New Port Facility Falkland Islands

Supporting statement to variation of condition application

Revision	Date	Description	Prep	Check	App
P02	24-Aug-2022	Final for planning submission	MS	RP	MS

Contract No:	Doc No:	Status	Revision
BAM	BAS.2051	BAS2051-RHD-ZZ-ZZ-FN-YE-5037	S4	P02
RHDHV	PB7829	PB7829-RHD-ZZ-ZZ-FN-YE-5037	S4	P02

STAGING AND PHASING
DRAWING

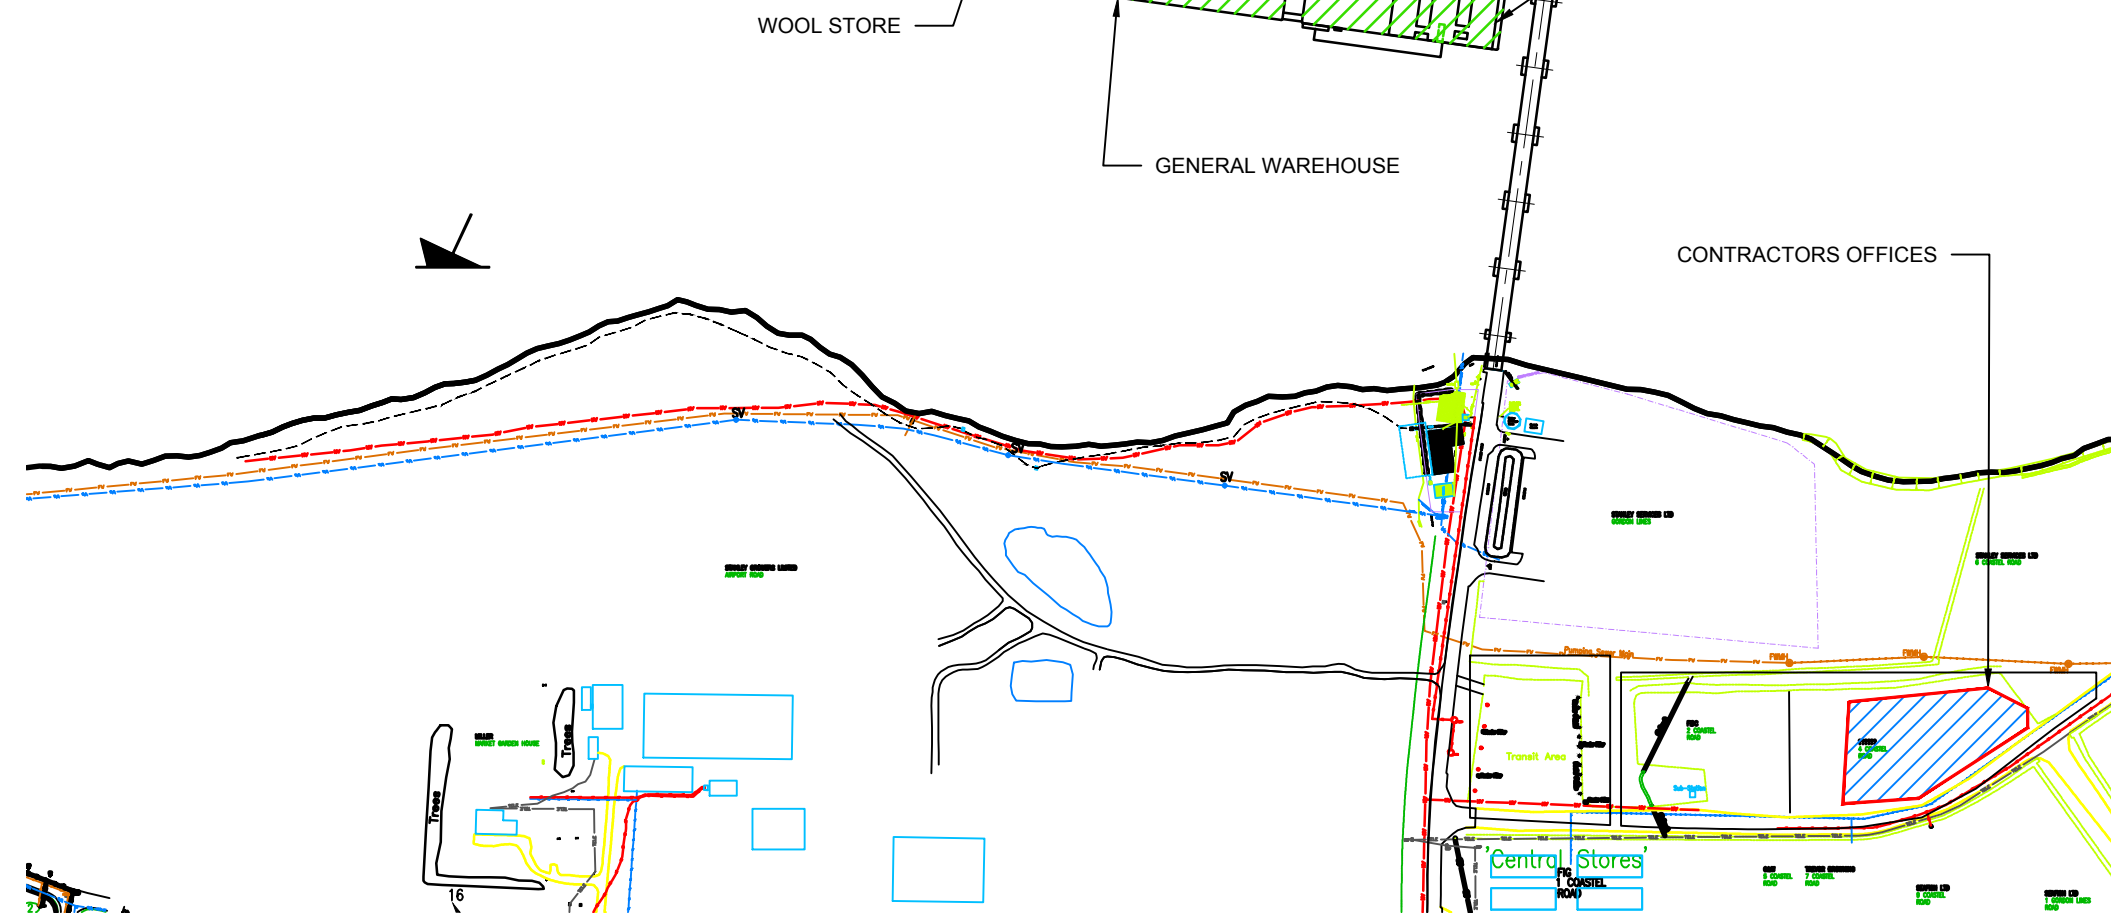
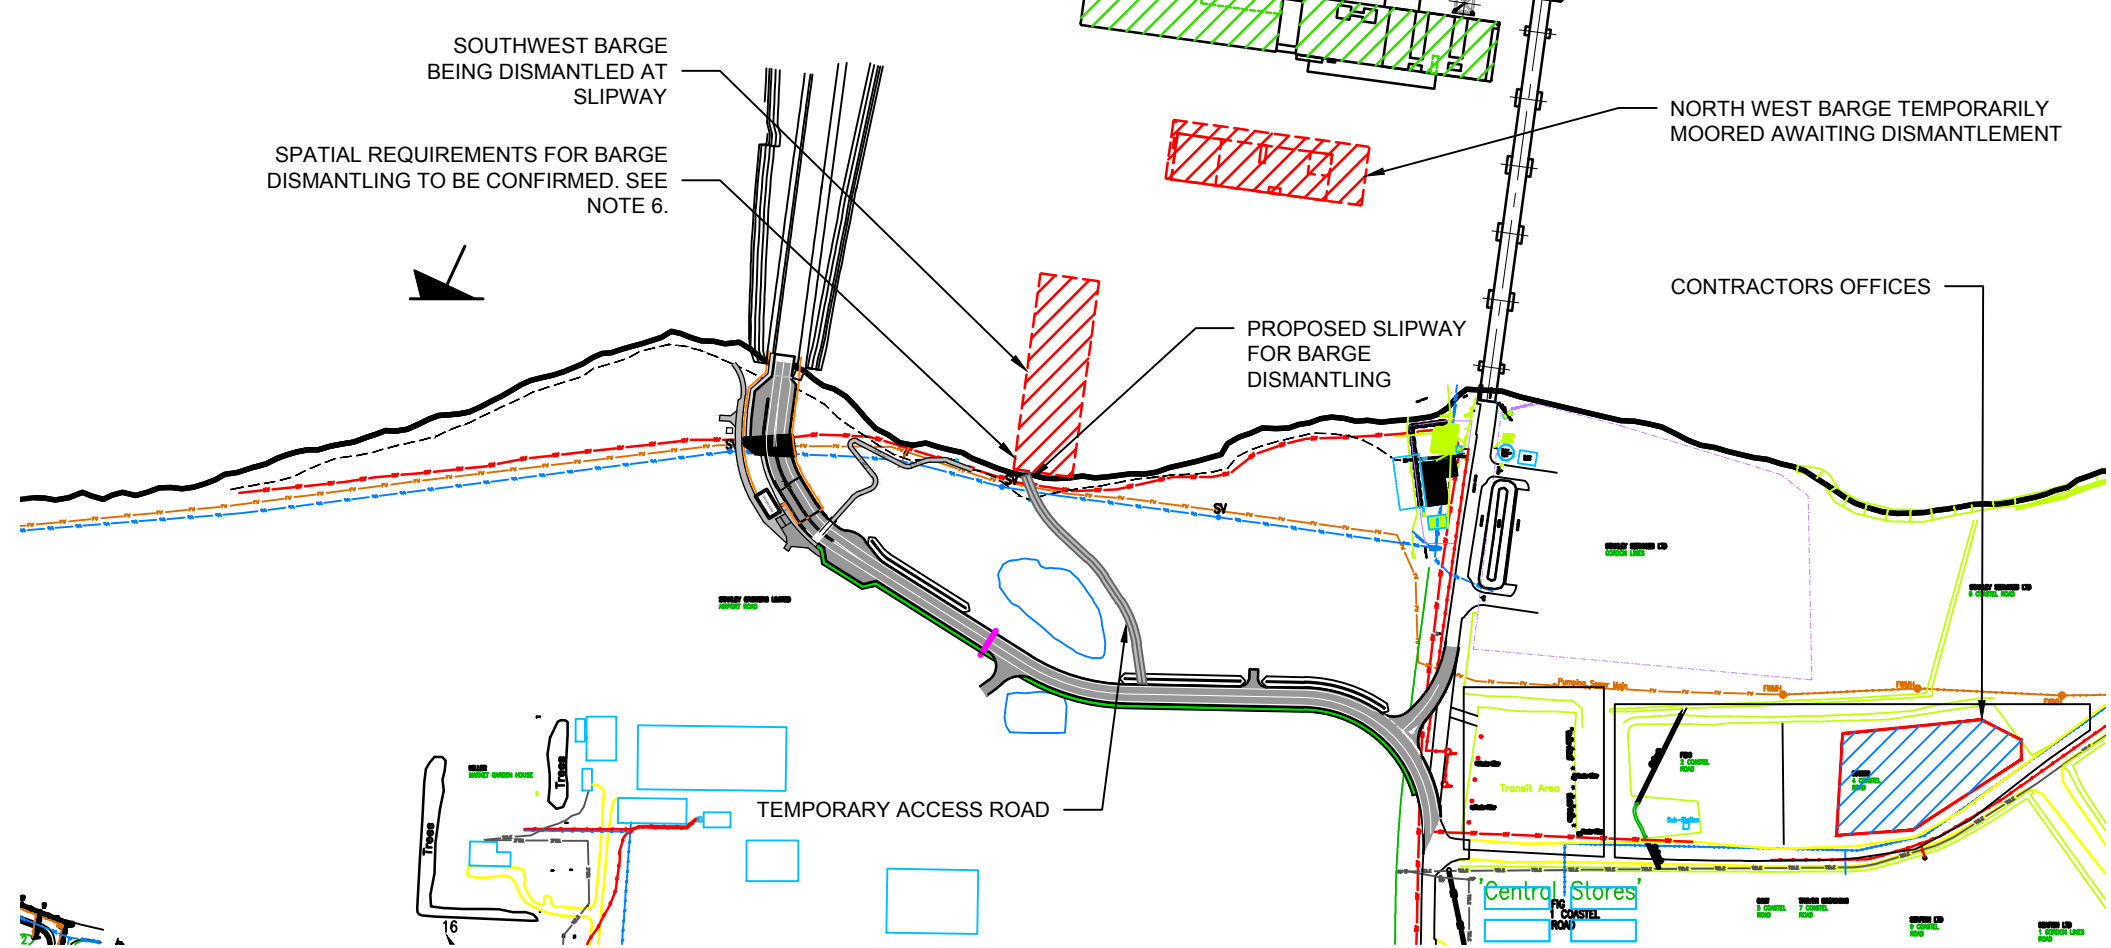
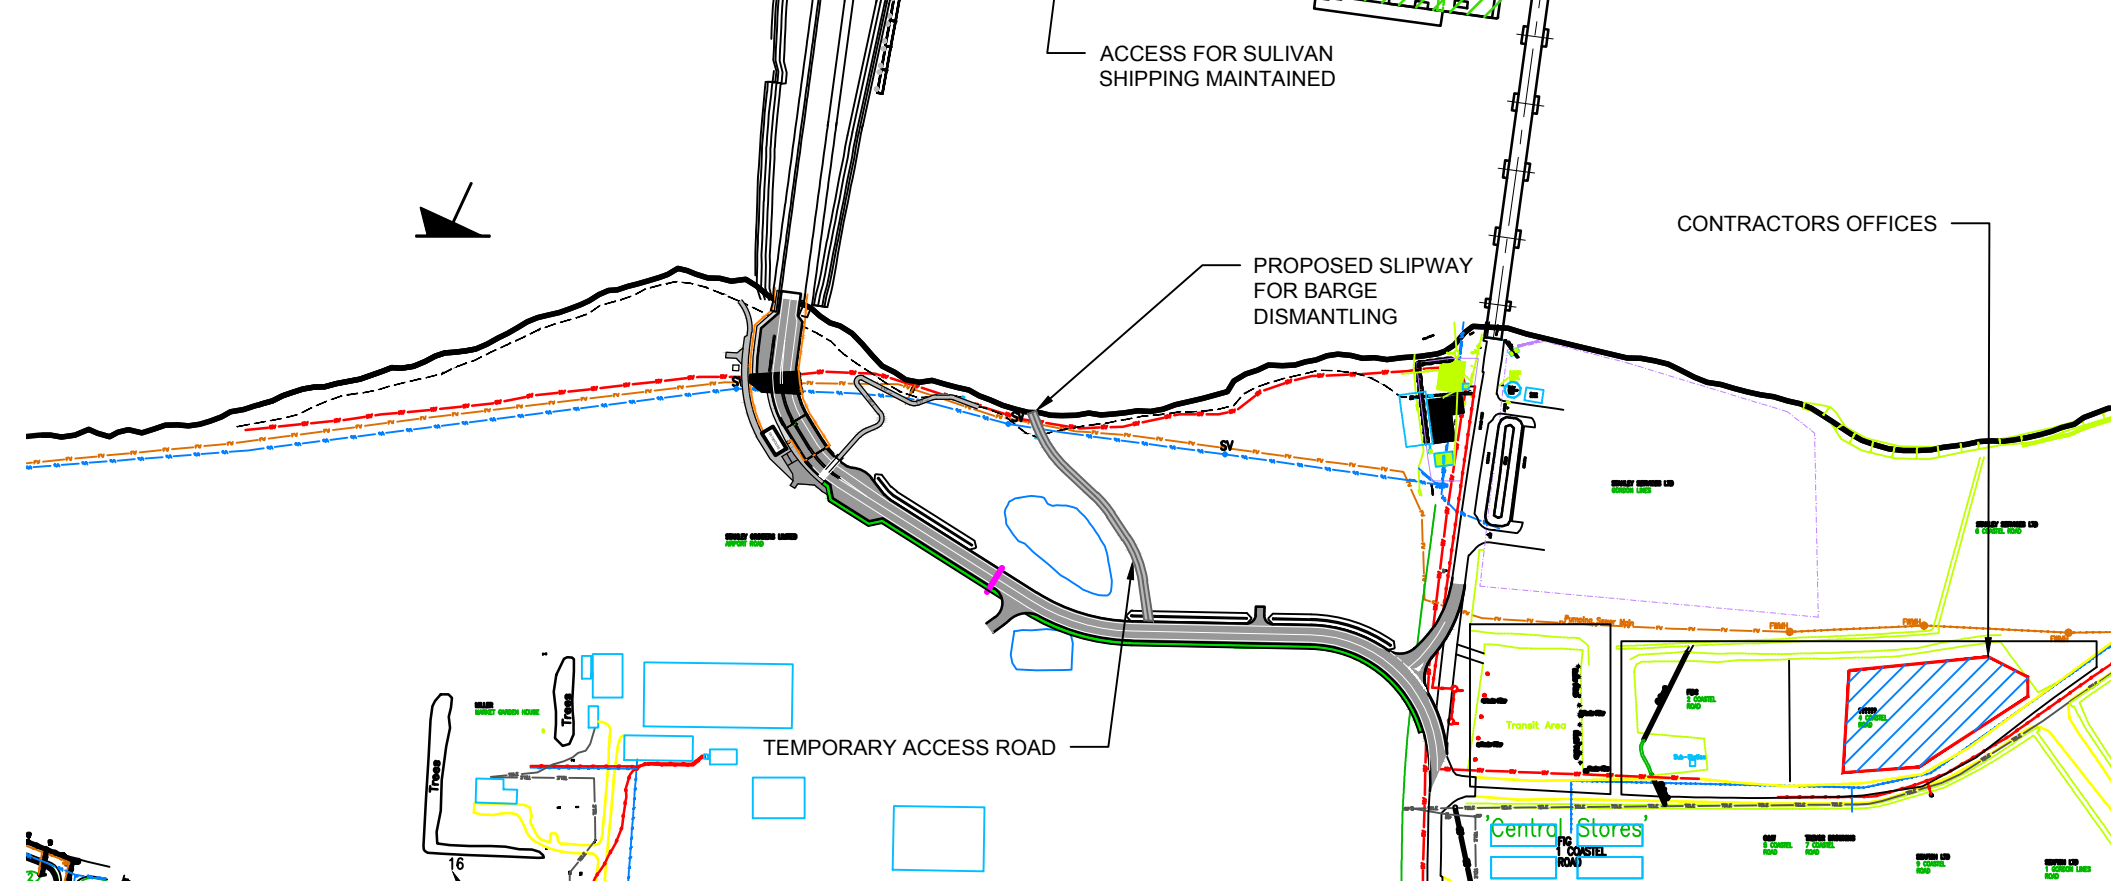
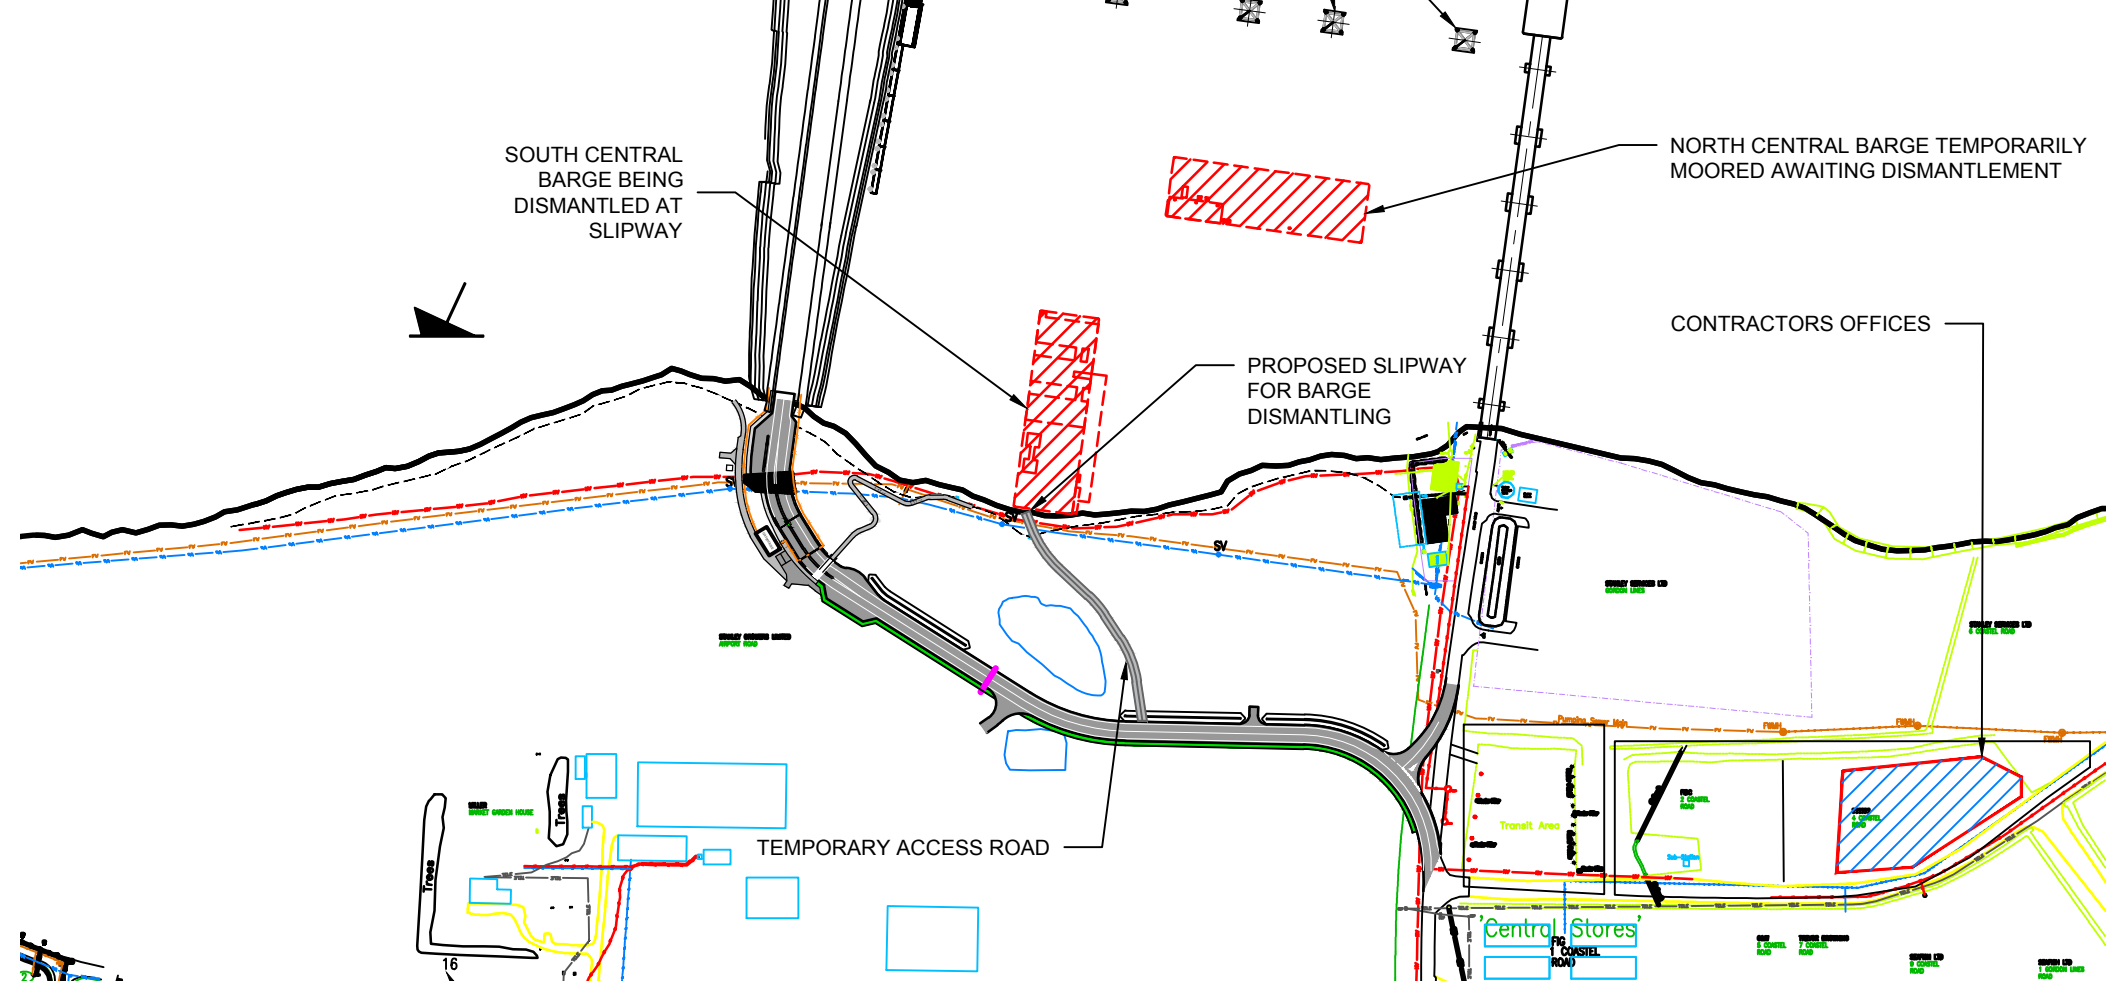
Variation to	Details	Primary condition or content affected
Drawings	Approved Plans updated, some of which are included as supporting drawings to the EIS.	Condition 2 – Approved Plans
